AGENDA
Planning and Zoning Commission
June 3, 2020 – REGULAR MEETING

TOWN OF JACKSON PLANNING COMMISSION AGENDA DOCUMENTATION

APPLICANT/OWNER: MR. RYAN STANLEY / SNOW KING MOUNTAIN RESORT

DRAWING NO C3.0	JOB TITLE SNOW KING MOUNTAIN RESORT 2020 IMPROVEMENTS JACKSON, WYOMING		DRAWING TITLE NIGHT SKIING LIGHTING PLAN		DATE 3/31/2020		REV 4/28/2020	
	JOB NO 19-262-01				SURVEYED NE	ENGINEERED NB	CHECKED DD	APPROVED DD

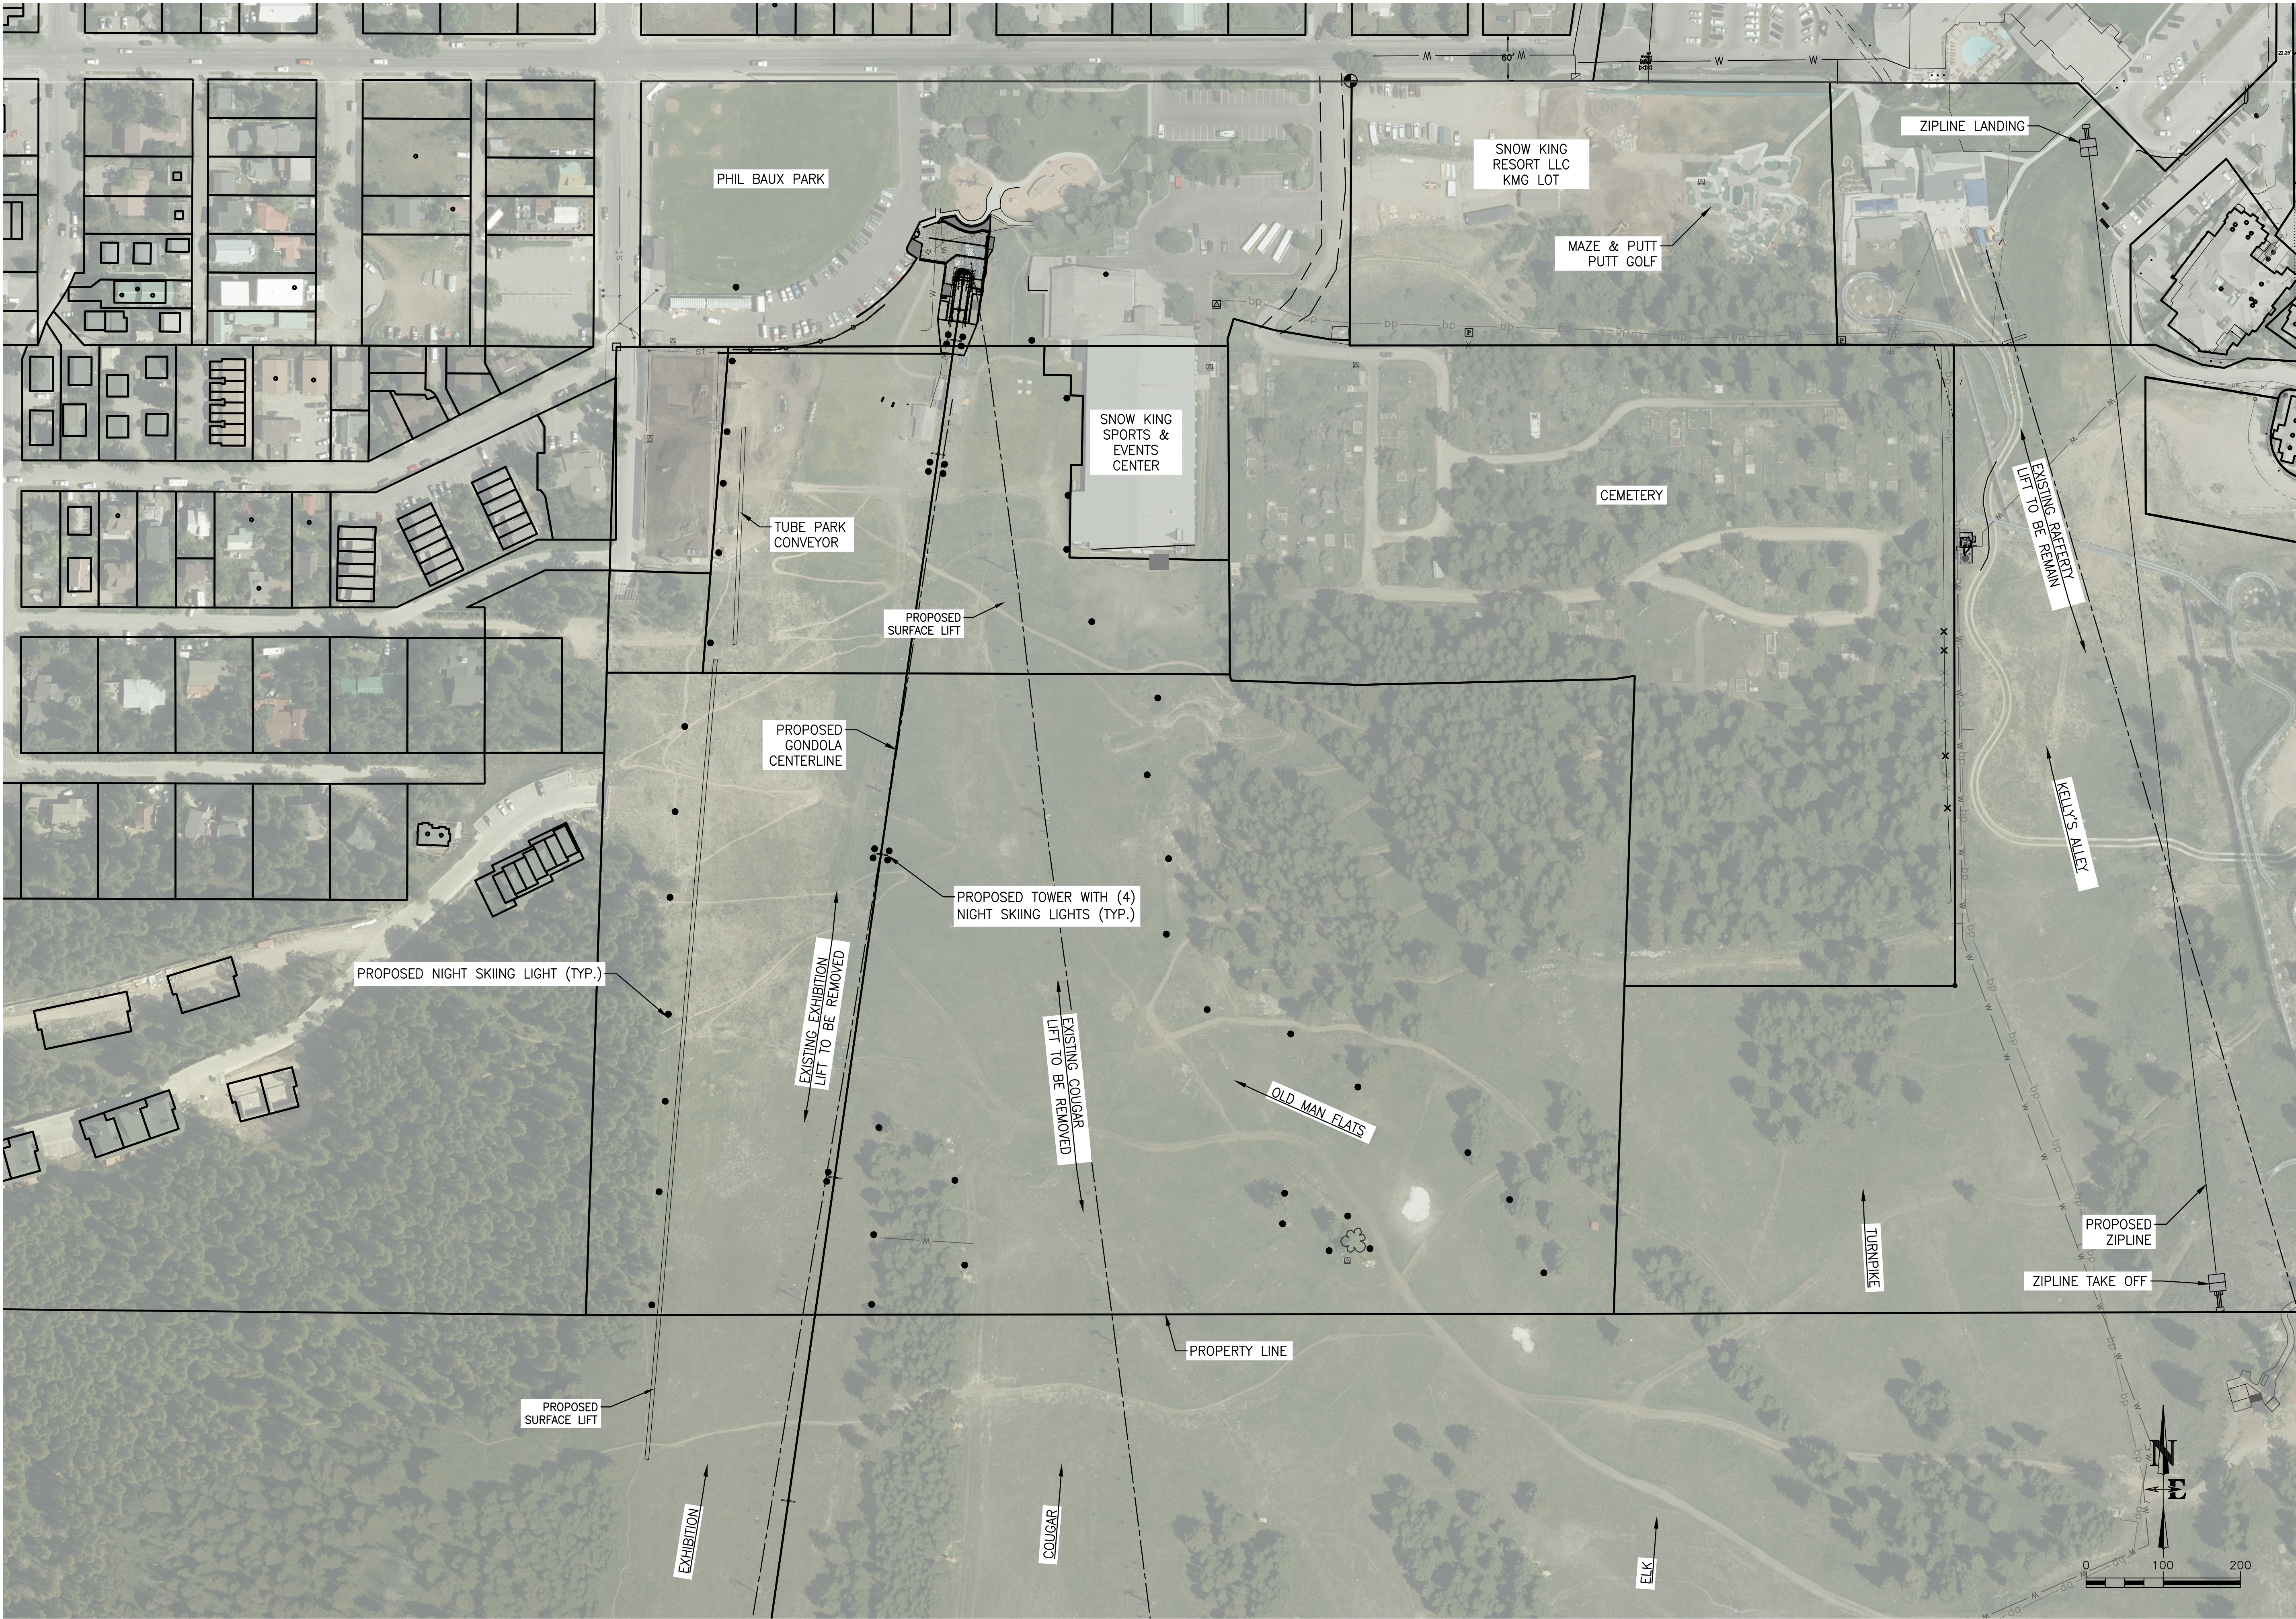
The applicant has submitted a Night Skiing Lighting Plan (sheet C3.0 of the applicant submittal) which indicates the location of proposed increased lighting for night skiing. In general, lighting is situated around the periphery and adjacent to stands of trees within the ski runs of ‘Old Man Flats’, ‘Cougar’, and ‘Exhibition’. The lighting extends down the slope alongside the tube park and event center towards the proposed gondola base area in Phil Baux Park.

Each Snow-Bright light is 300 watts, and according to the "Snow-Bright™ 300-Watt round floodlight" manufacturer's cut sheet, each light has an average of 100 Lumens per Watt, or 30,000 lumens per light. The applicant's night skiing plan totals 100-200 such lights which would equate to roughly 3 to 6 million lumens for this location of the ski hill shown on the lighting plan. However, according to the exemption for complex uses, a lighting plan in excess of the 550,000 lumen limit can be approved as part of a Conditional Use Permit. Therefore, staff suggests that the Planning Commission discuss the proposed lighting plan and proposed increase in total lumens on site. Please see the applicant's supplemental information letter and email correspondence for more detail and links to the manufacturer's webpage regarding the lights and their use at other ski areas.

The applicant has clarified that keeping the Cougar lift on the ski hill will add an estimated additional 8-16 additional lights at 3-4 locations. The applicant states that a range of additional lights for Cougar is proposed at this time because there is likely some redundant locations with the lift staying that will not be necessary elsewhere. Ultimately, the applicant states that they are trying to improve the visibility on the snow and Cougar remaining helps that situation substantially by retaining lighting locations more in the middle of the run.
